Replace Charge Port Insulator Pins

Classification	Campaign Bulletin	Section/Group	44 - High Voltage System	Country/Region	United States, Canada
Year	2017-2019	Model	Model 3	Version	All

Figure 7

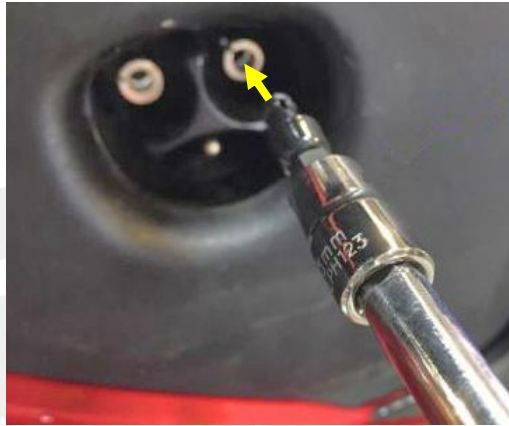
14. Insert the new charge port insulator pins into a 3 mm hex socket, and then use an extension to push the insulators into the charge port assembly power terminals until they are seated (Figure 7).

⚠ CAUTION: Make sure that the new charge port insulator pins are fully seated on the terminals of the charge port assembly.
